Illinois Tollway Standard Drawings Revisions

Section L	Fiber Optic	
Standard	Modification Summary	Effective: 03-1-2022
L1-04	Fiber Optic System Typical and Drawings	
Sheet 1	Modified Note 3. Added "or compression coupled".

VERSION: 2022-03	STANDARD: L1-04	SHEET: 1 OF 15
---------------------	--------------------	-------------------

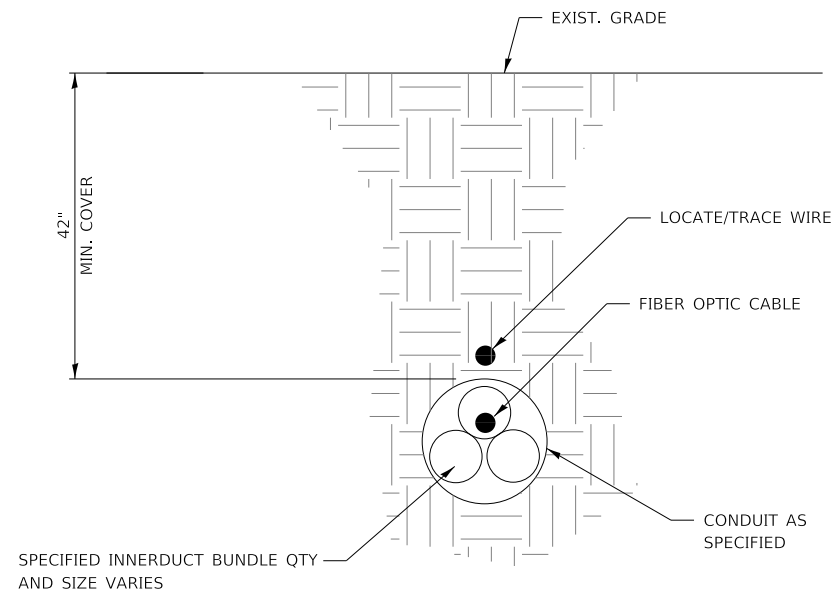
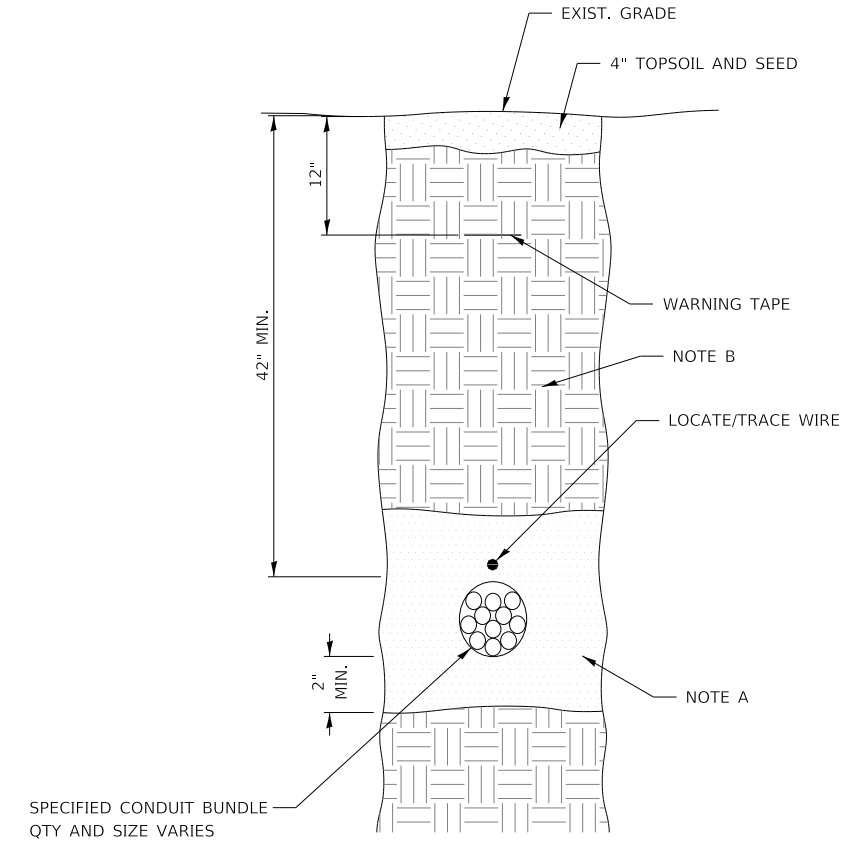
Sheet 1	Modified Note 4. Replaced "PVC coated galvanized rigid steel" with "stainless steel".	
Sheet 2	Modified Note 4. Added "or compression coupled".

3. IF WHILE LOWERING THE CONDUIT THERE IS NOT ENOUGH SLACK, ADDITIONAL CONDUIT SHALL BE ADDED. EMPTY CONDUITS CAN BE CUT AND HAVE NEW CONDUIT FUSED OR COMPRESSION COUPLED ON. CONDUITS WITH FIBER INSTALLED SHALL BE RING CUT WITH A TUBE CUTTER SO AS NOT TO DAMAGE THE FIBER.

4. CONDUIT USED ABOVE GROUND SHALL BE STAINLESS STEEL OR FIBERGLASS REINFORCED EPOXY (FRE) CONDUIT. UNDERGROUND CASINGS SHALL BE FRE PER THE SPECIAL PROVISIONS OR HDPE.

VERSION: 2022-03	STANDARD: L1-04	SHEET: 5 OF 15
---------------------	--------------------	-------------------

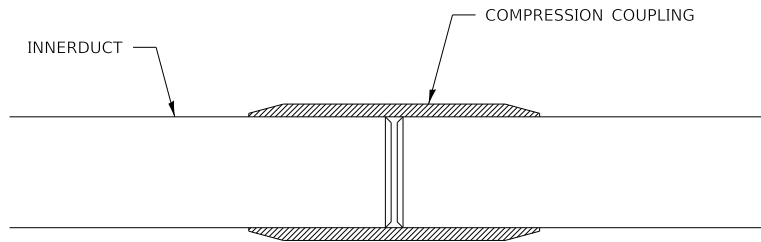
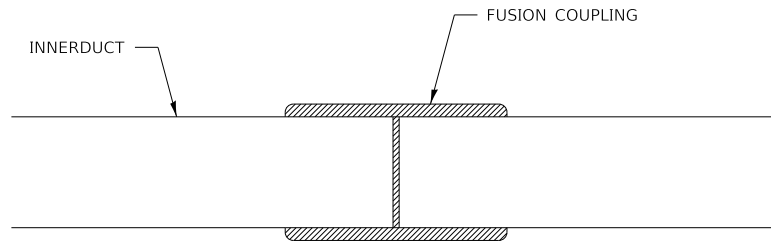
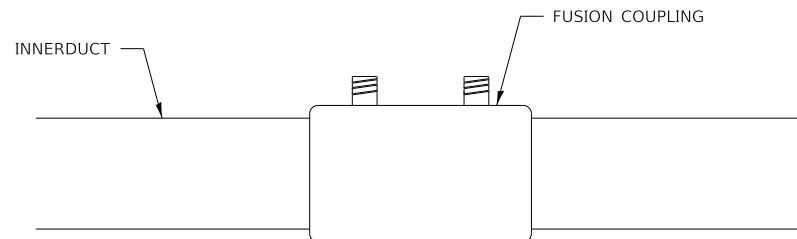
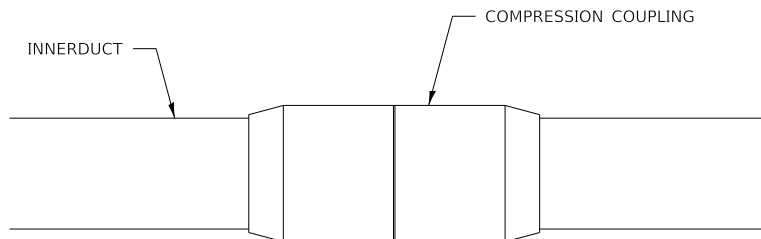
Sheet 2	Modified Note 11. Replaced "PVC coated galvanized rigid steel" with "stainless steel".	
Sheet 2	Modified Profile View. Removed "HDPE".	
Sheet 5	Modified title. Removed "Fusion".

Sheet 5	Added compression coupling detail.	
Sheet 6	Removed note that stated "all bolts shall be 1/2" x 3" hex ASTM standard F593C stainless steel bolts".

COMPRESSION COUPLING DETAIL

1. FUSION OR COMPRESSION COUPLINGS SHALL BE USED. INSTALL COMPRESSION COUPLINGS PER MANUFACTURER RECOMMENDATIONS.

FIBER OPTIC SYSTEM TYPICALS AND DRAWINGS		
VERSION: 2022-03	STANDARD: L1-04	SHEET: 6 OF 15

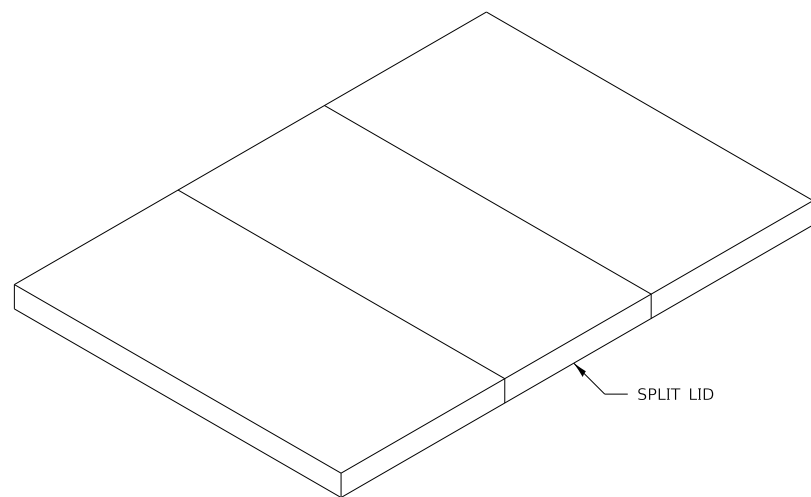
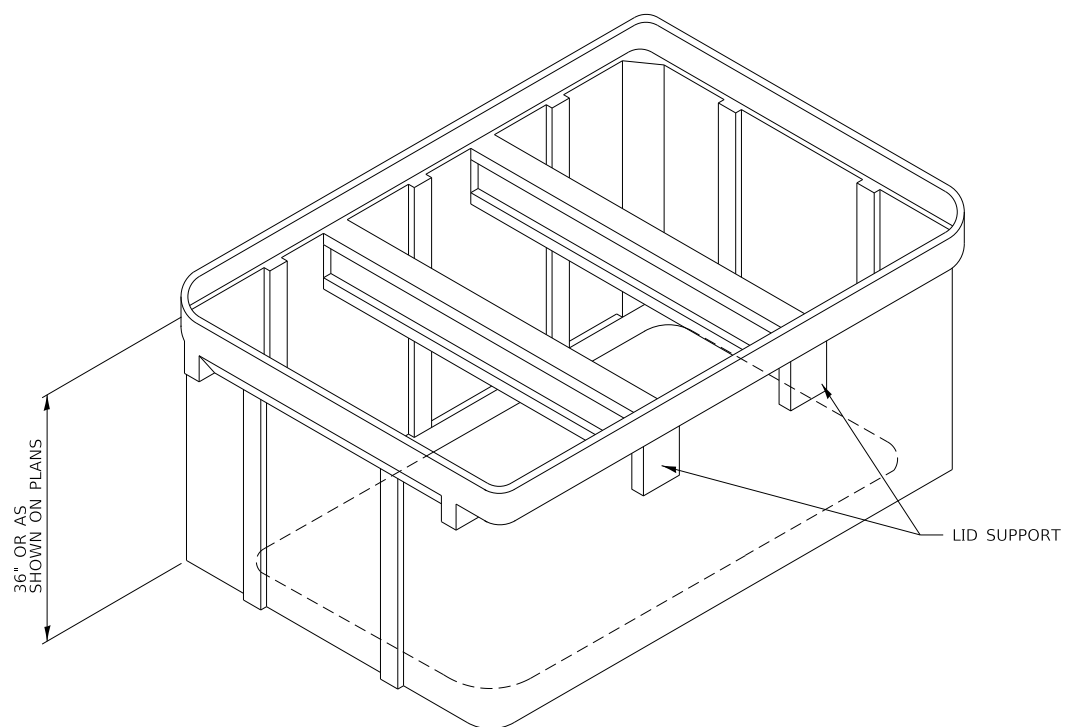
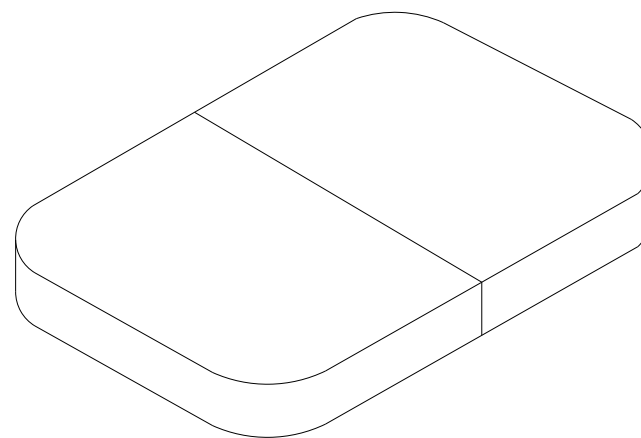
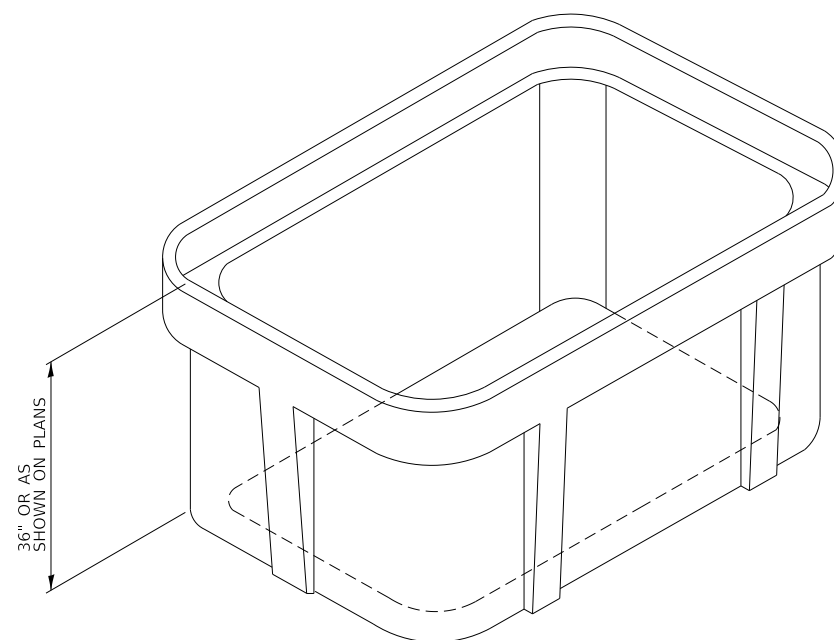
Sheet 6	Added depth dimension to detail.	
Sheet 6	Modified detail. Removed bolts and bolt holes from the lid drawing. Updated the hash line work on the drawing.

VERSION: 2022-03	STANDARD: L1-04	SHEET: 8 OF 15
---------------------	--------------------	-------------------

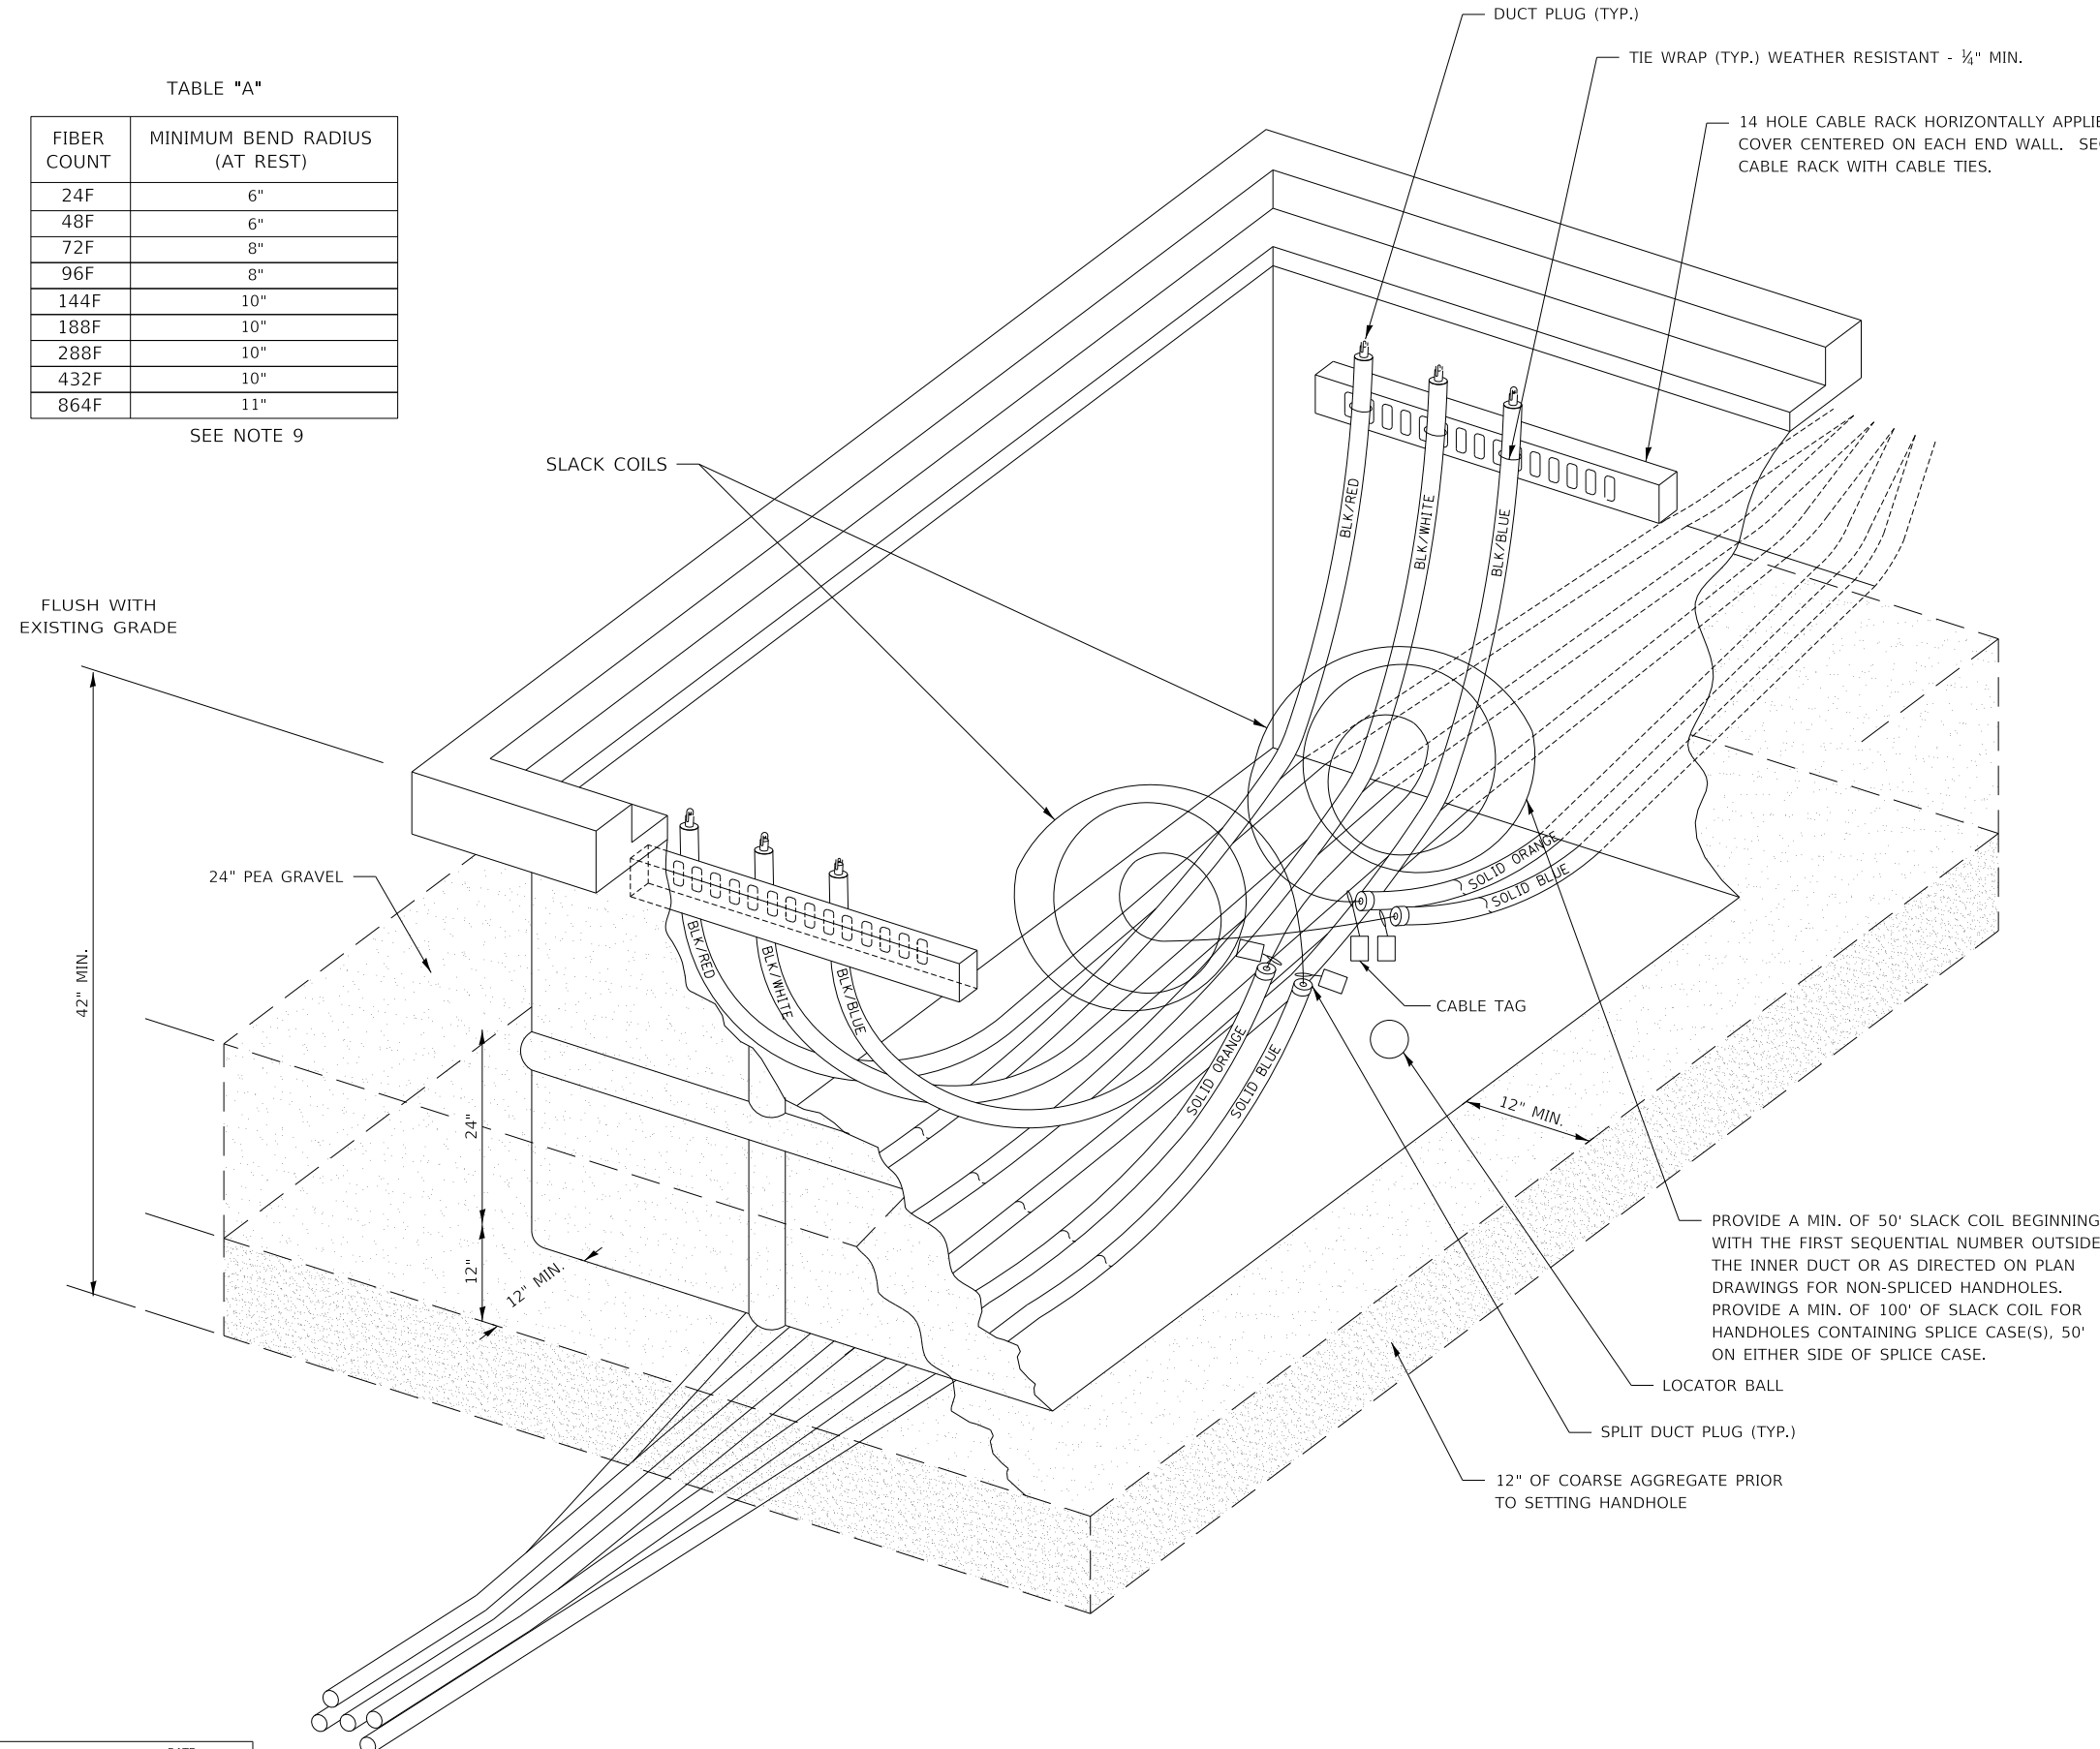
Sheet 8	Modified detail. Added a locator ball.	
Sheet 8	Modified detail callout. Replaced "pea gravel" with "coarse aggregate".	
Sheet 8	Added a new note that states "locator ball shall be placed in handhole containing a splice enclosure. Place locator ball in the middle of handhole".

9. MANUFACTURER'S SPECIFICATIONS OF MINIMUM BEND RADIUS SUPERCEDE TABLE "A".
10. LOCATOR BALL SHALL BE PLACES IN HANDHOLES CONTAINING A SPLICE ENCLOSURE. PLACE LOCATOR BALL IN THE MIDDLE OF HANDHOLE.

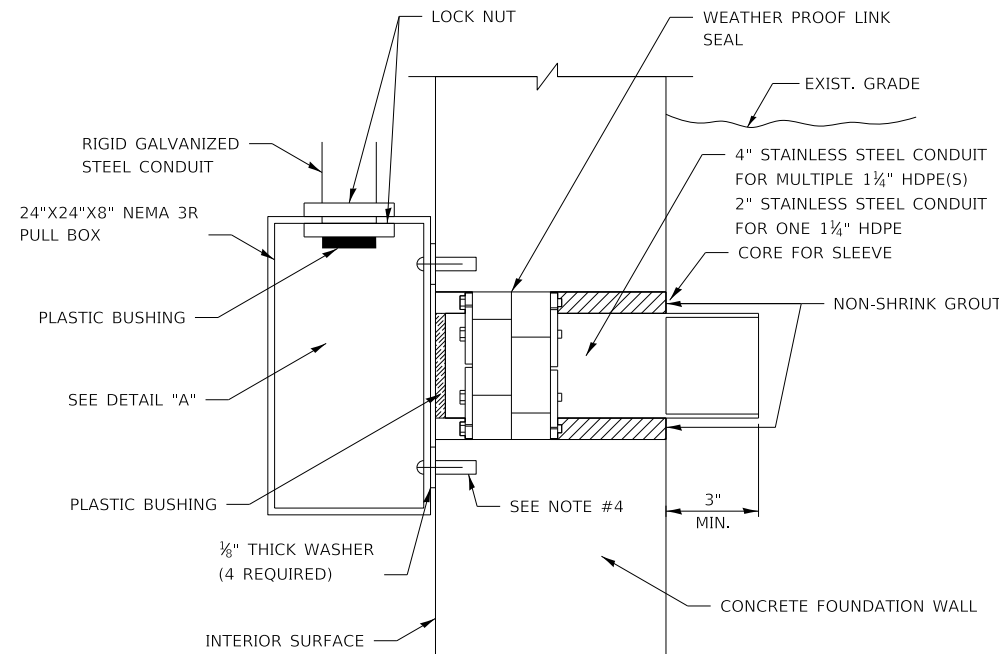
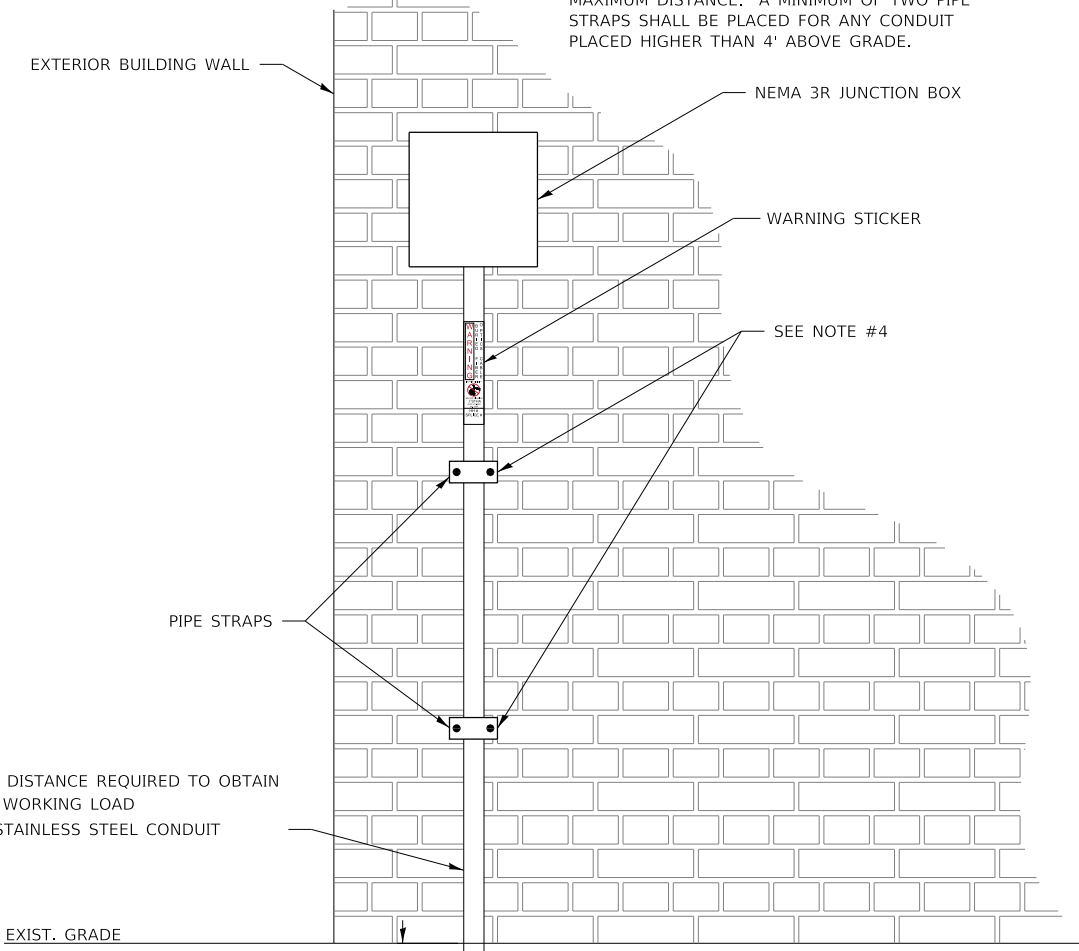
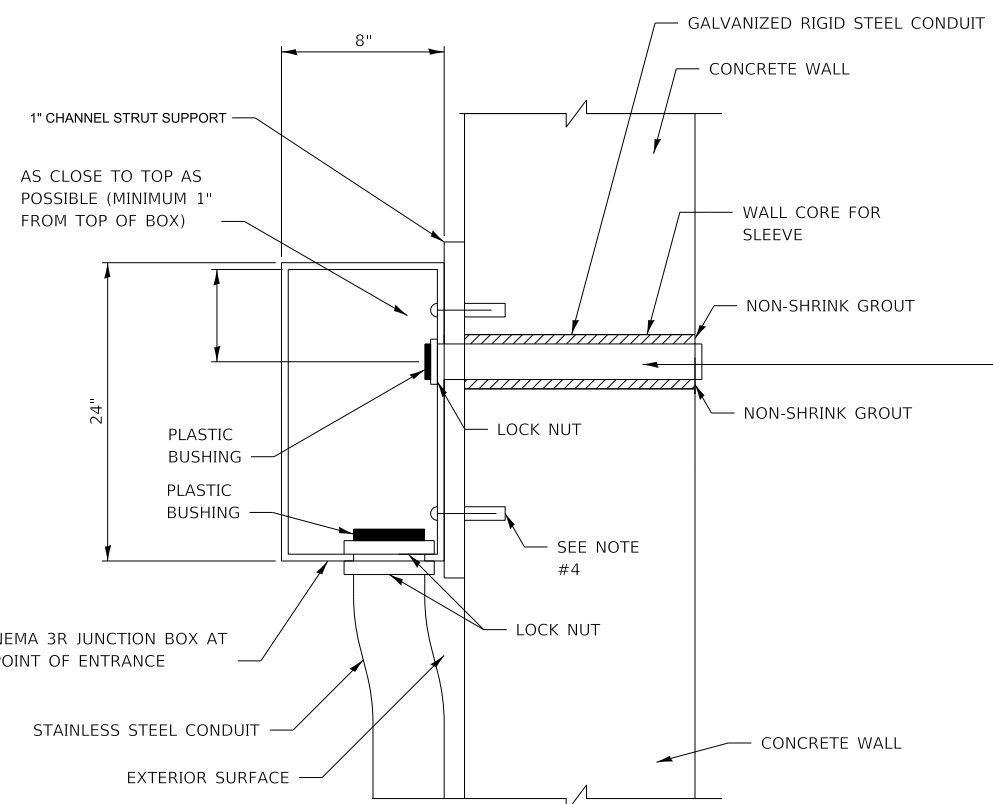
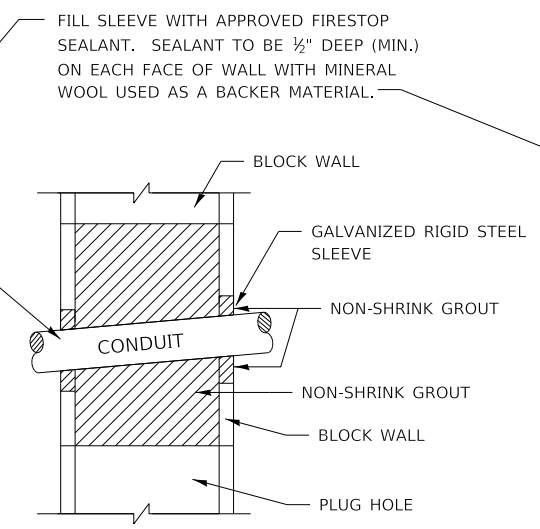
Sheet 11	Modified Detail B callout. Replaced "galvanized rigid steel" with "stainless steel".	
Sheet 11	Modified Detail C callout. Replaced "galvanized rigid steel" with "stainless steel".

Sheet 11	Modified Detail D callout. Replaced "galvanized rigid steel" with "stainless steel".	
Sheet 11	Modified Detail D. Added a 1 inch channel strut support between the cabinet and concrete wall.
